Appl. No. 09/740,559 Amdt. dated April 21, 2005 Reply to Notice of Non-Responsive Amendment

# **Amendments to the Drawings:**

Application No.: 09/740,559
Applicant: Bridget D. Kimball et al.
Title: AUTHORIZATION CONDITIONED OBJECT MESSAGE DOWNLOAD
Sheet 4 of 7

Fig. 7

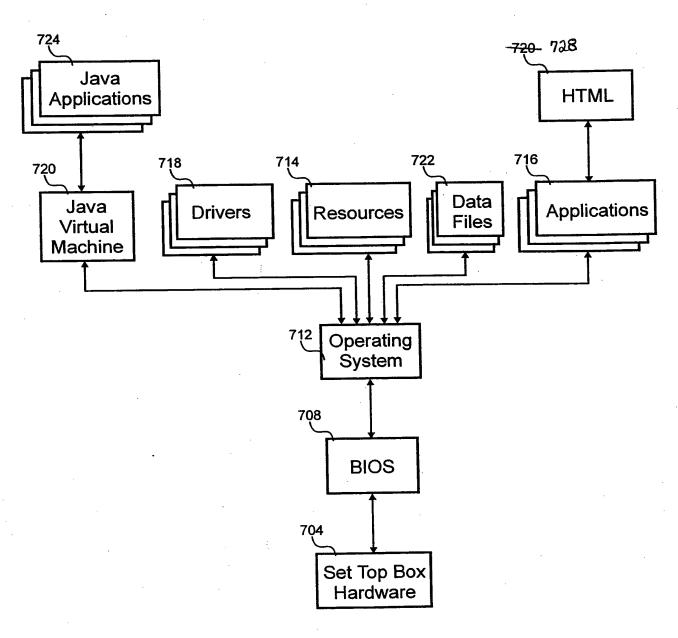
The attached sheet of drawings includes changes to Fig. 7. This sheet, replaces the original sheet including Fig. 7.

The description and Figure 7 are amended to correct several oversights that are grammatical, clerical or typographical in nature. These oversights are noted in paragraphs 1-4 of the Office Action. Paragraph 2 of the Office Action notes a problem with reference designator 1034, which does not appear on the figures. Our amendment presumes reference designator 1044 was intended instead of 1034.
